<i>Enquiries to</i>	Matt Grantham	<i>My reference</i>	059060
<i>Direct Line</i>	N/A	<i>Your reference</i>	RM/25/100615
<i>Date</i>	29 January 2026	<i>Email</i>	eastleighdc@hants.gov.uk

Re: RM/25/100615 At Land West of Burnetts Lane (The Holme and Homestal), Horton Heath, Eastleigh, SO30 2HH

Submission of Reserved Matters relating to Layout, Scale, Appearance, and Landscaping pursuant to Condition 4 (RM Requirements) of Outline Planning Permission O/20/89498 for the erection of 357 dwellings within Phases 13A and 14 (The Holme and Homestal), with associated public open space, landscaping, and cycle and vehicular parking, to include details relevant to the following conditions:

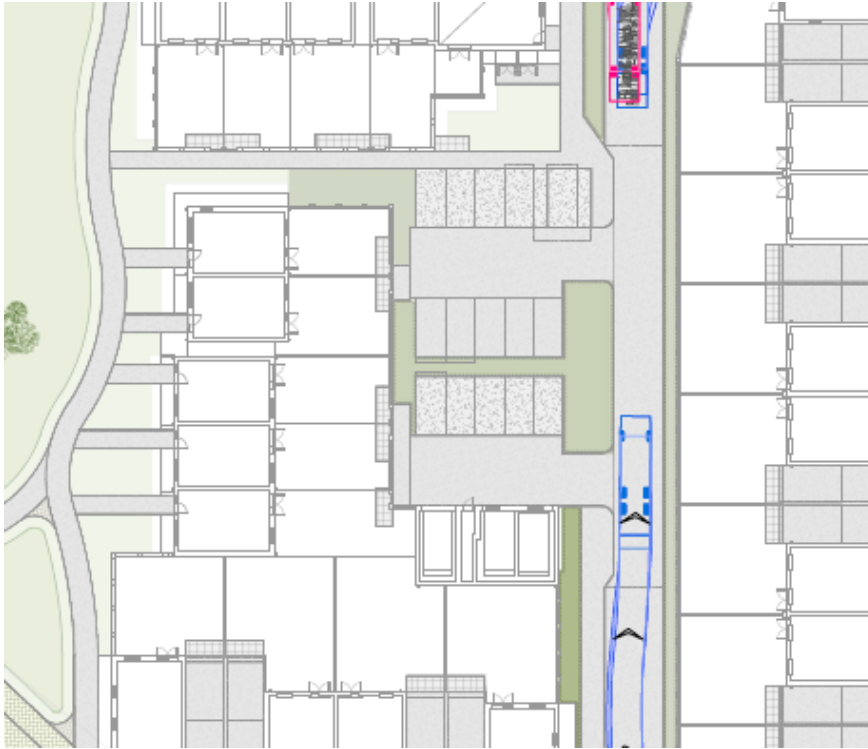
Whilst the refuse vehicle tracking (drawings 332612639-STA-ZZ-XX-DR-T-5002 Rev P01, 332612639-STA-ZZ-XX-DR-T-5003 Rev P01, and 332612639-STA-ZZ-XX-DR-T-5004 Rev P01) are largely acceptable, demonstrating how the vehicles can move around the site, it is noted that no two-way movements also showing a family vehicle have been provided. It would be recommended that the Case Officer requests this, as two-way movements look very tight to achieve in places, and the drawings will also identify any pinch-points for two-way refuse against car movements. This may onwards either require a private parking restriction or a localised widening of the road to ensure that refuse collections can be undertaken without obstructive incident.

Additionally, the Case Officer may wish to seek clarification as to how all refuse collections can be undertaken, in consultation with the EBC Direct Services Team. Whilst the majority of the site appears to be easily serviced, there are areas where this is unclear, such as side cul-de-sacs which may need appropriate bin collection points.

Unfortunately, the 'Proposed Site Plan' does not include plot numbers, so listing such instances is tricky, however for example, the following screen shot demonstrates both a tightness of carriageway for a refuse vehicle, as well as an area where a bin collection point may be advantageous.

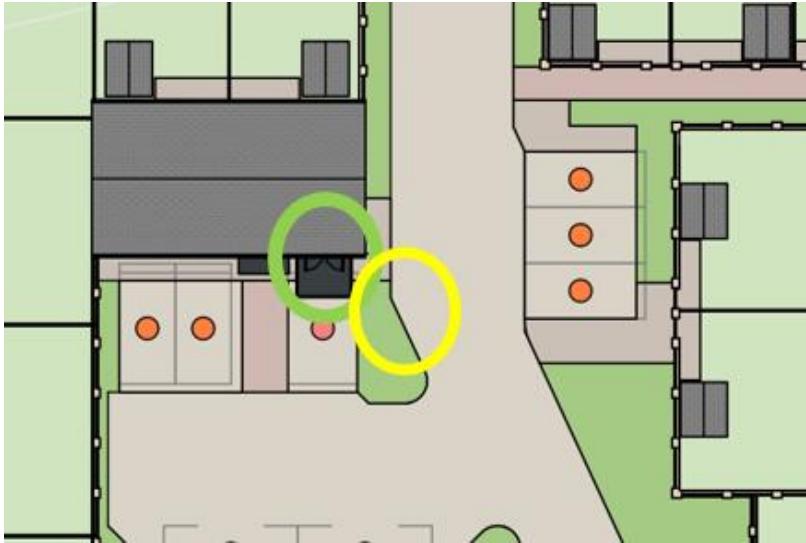
There are however a couple of areas of layout where parking could be problematic and potentially require updates if the site were to become adopted highway, and the Case Officer may wish to consider these.

1. Parking spaces located within the visibility splays as outlined above;
2. The aisle width for a parking space located on the eastern half of the site looks to be constrained by a slightly undersized aisle width that could easily be resolve by a slight amendment to landscaping (see yellow circle below); and

3. A parking space located on the eastern side of the site appears to have a canopy overhang encroaching into it. This should be investigated and potentially removed if it is of a height that could prevent larger SUV's or vans from utilising the space (see green circle below).
